Application No.: 10/054,755
Filed: November 12, 2001
Reply to Office Action of January 24, 2004

AMENDMENTS TO THE DRAWINGS:

REMARKS:**Summary of Amendments**

Annotated Sheet Showing Changes

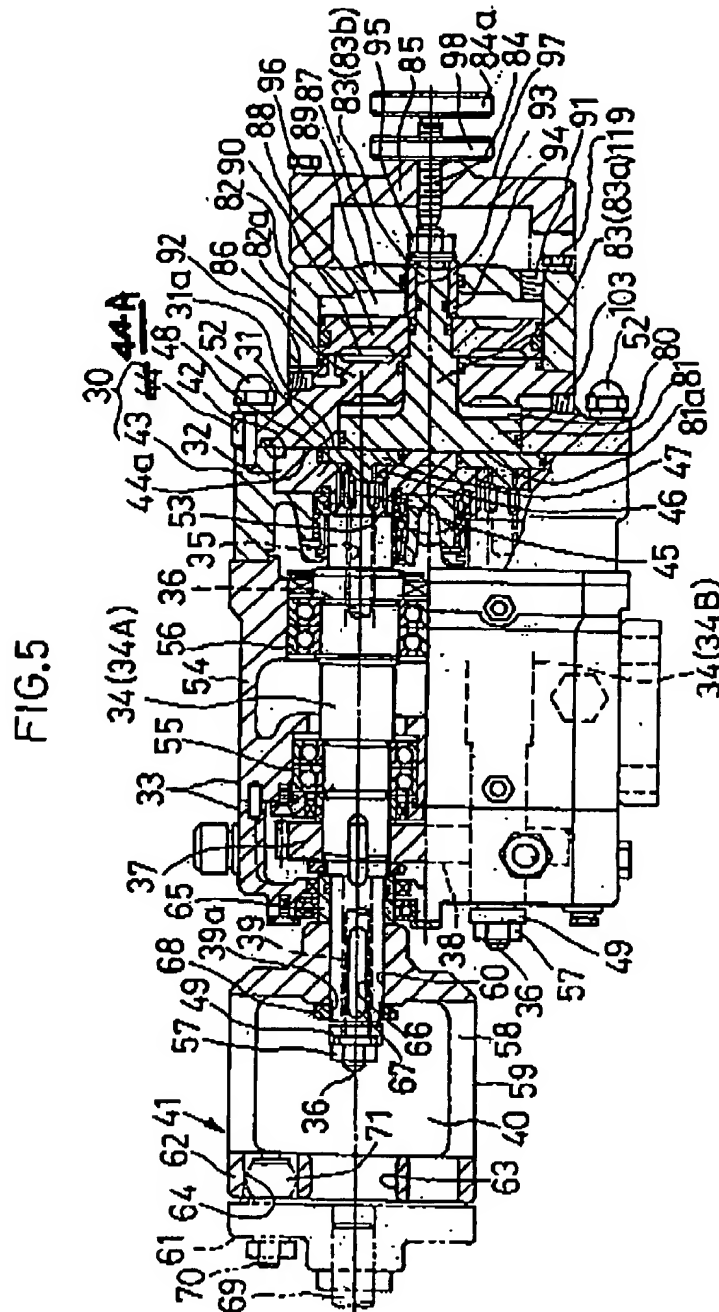
The attached sheet of drawings includes changes to FIG. 5, FIG. 6, FIG. 7, FIG. 8, and FIG. 9. This sheet, which includes FIGs. 1-11, replaces the original sheet including FIGs. 1-11. In FIG. 5, FIG. 6, FIG. 7, FIG. 8, and FIG. 9, previously mislabelled numbers have been amended.
